(Shearon Harris Nuclear Plant)

Docket No. 50-400-OL

MEMORANDUM AND ORDER
(Limited Reopening of the Record
on Eddleman Contention 57-C-3)

Figure 1

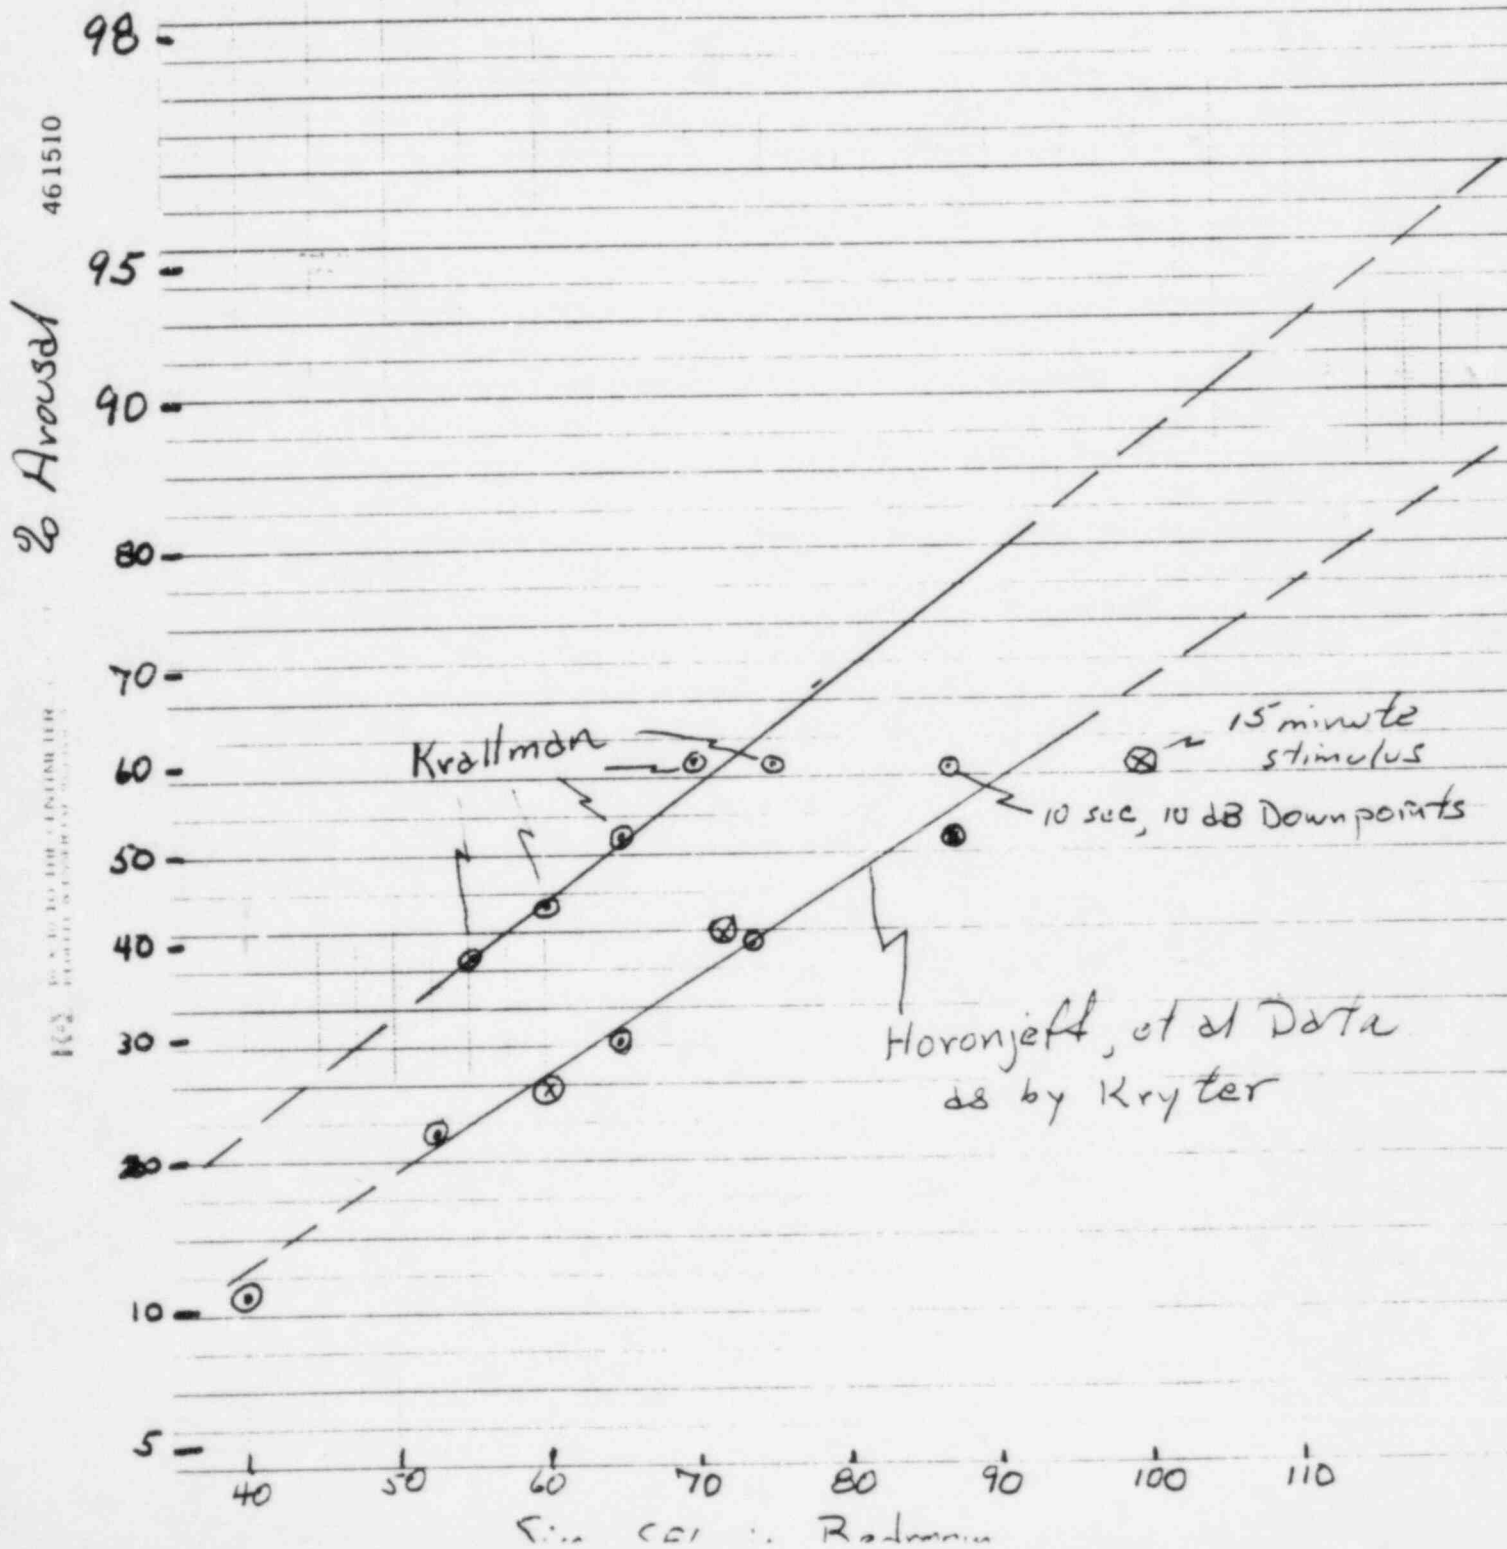
1. The Board has counted the houses as a function of sound levels that are shown in Applicants' Exhibit 46 as being located within 5 miles of the Harris plant. This exhibit is marginally legible and the Board expects that a few (perhaps tens) of houses may have been missed in our count. This modest possible inaccuracy does not appear to be significant. The structure of the resulting table is identical to Attachment 5 of the Keast, et al., testimony.
2. Assume Figure 1 describes Horonjeff, et al., and Krallmann data sets

3. The Board, in making the approximate calculations supra, used the Kryter approximation for converting siren dBA Levels to SELs (Kryter at 26). Review of the FST Model 1000 directionality characteristics, recently filed by Applicants, suggests, as per figure 2, that this approximation may significantly understate the actual acoustic stimulus produced by the sirens functioning. We would like to explore this issue on the record.
